VARIANCE STAFF REPORT

Case No. and Project Name: PZ2023-81 McCahey Property

Requested Action: Variance to Land Development Regulations (LDR) Section 6.01.04(A)(1)(a) to allow a residential addition to be constructed 5-feet from the ordinary high-water line, mean high water line, or jurisdictional wetland line, in lieu of the required 50-feet.

Attachment "C" – Plot Plan

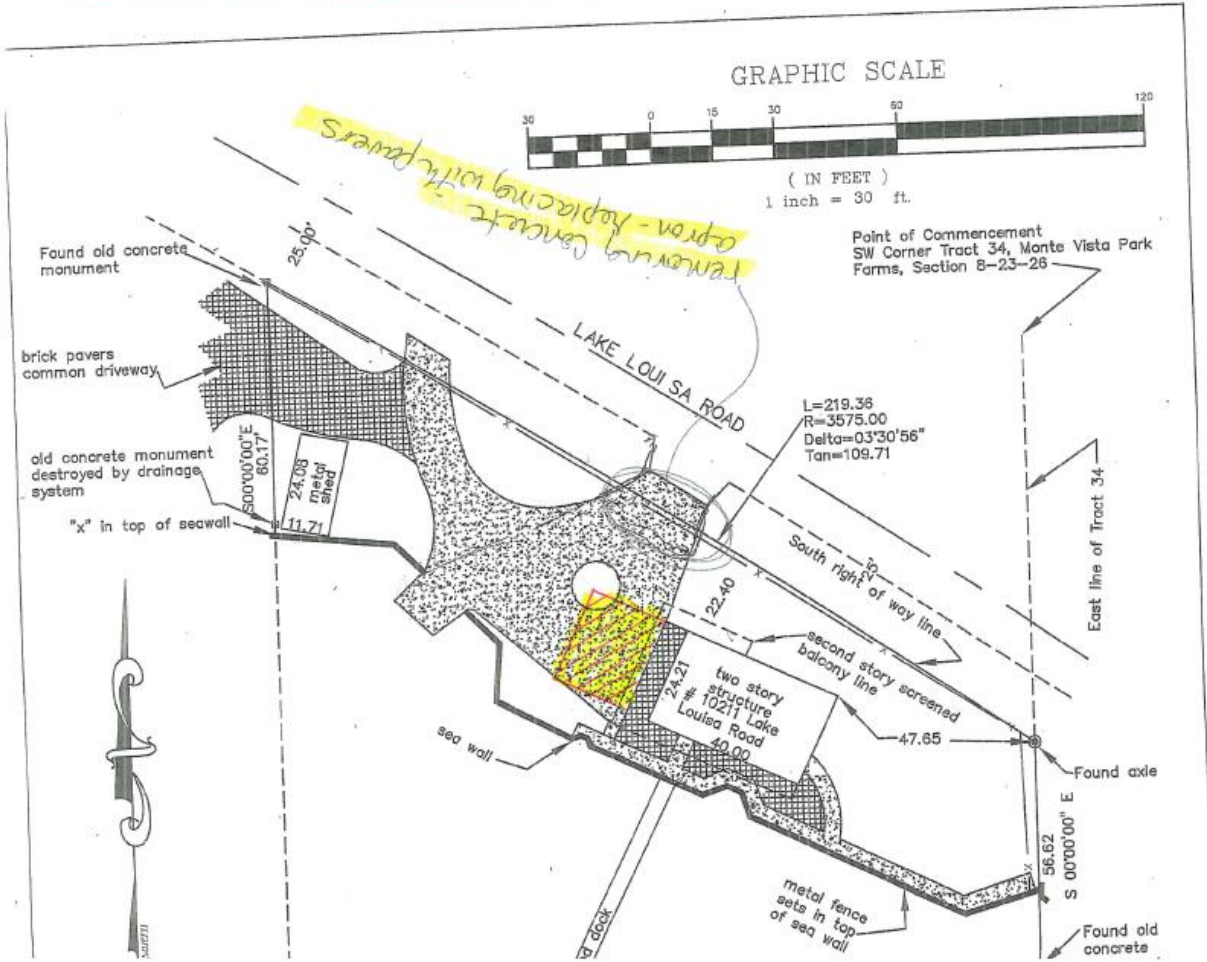
Yes. As seen in Attachment “C”, the residential addition proposed dimension is 15-feet in width by 23-feet in depth.

Yes. As depicted in Attachment "C", the proposed residential addition is proposed to be constructed the same distance from the seawall as the existing single-family residence.

5. An interceptor/environmental swale that is sized to capture the first 1-inch of stormwater runoff from the imperious area of the parcel shall be provided on site. An engineered design that includes a plan

and calculations must be submitted with the permit application for the improvement/addition for the site.
